Product Change Notification

Change Notification #: 115536 - 00
Change Title: Intel® Ethernet Network Connection OCP X527-DA2 Product Code X527DA2OCPG1P5 MM#950126,
Intel® Ethernet Network Connection OCP X557-T2 Product Code X557T2OCPG1P5 MM#950179,
PCN 115536-00, Product Design, Label, Product Material,
Update FRU images in X527DA2OCPG1P5 and X557T2OCPG1P5 and X557T2OCPG1P5 bracket change.
Date of Publication: May 30, 2017

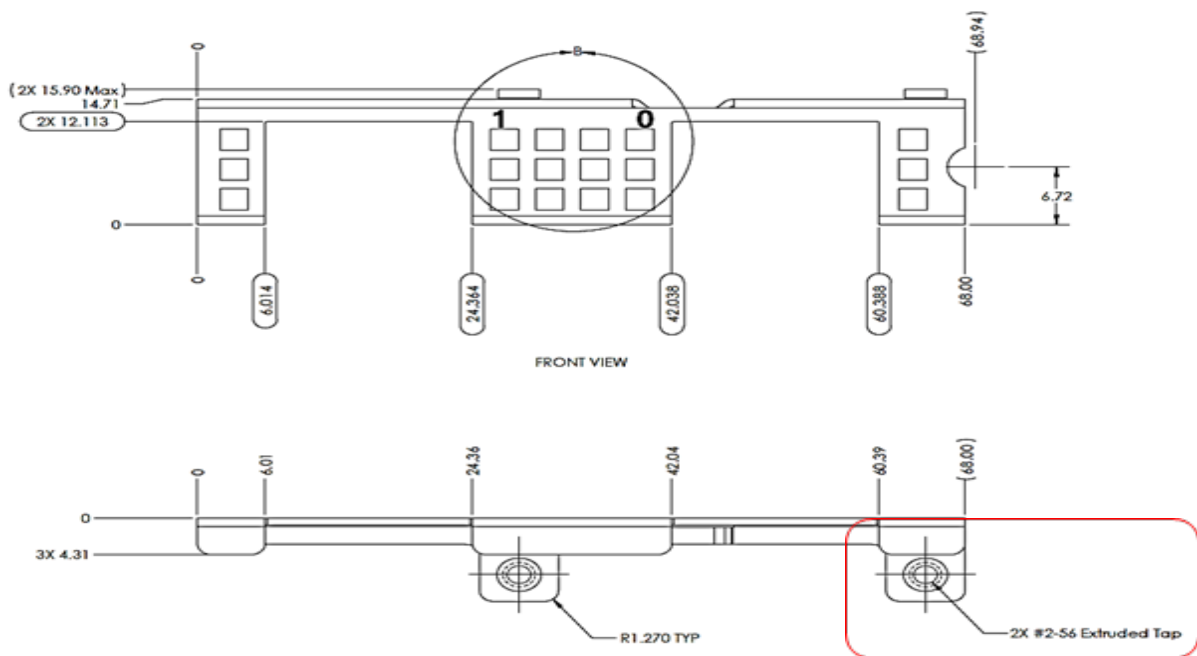
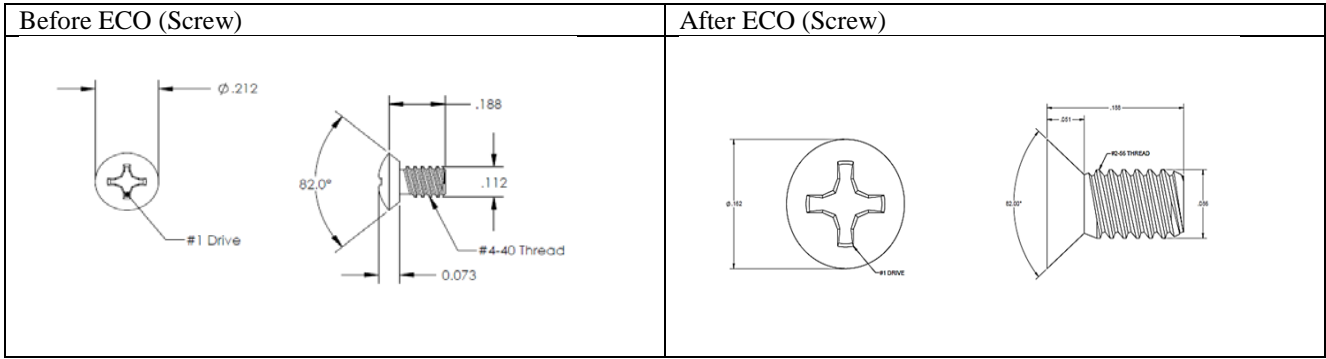
- X527DA2OCPG1P5, Rev Product Code and MM#, Roll TA and PBA
- X557T2OCPG1P5, Rev Product Code and MM#, Roll TA and PBA.
- Replace bracket and screw H91023-001, C94179-001 (2ea.) with H91023-002 and G42652-001 (2ea.)
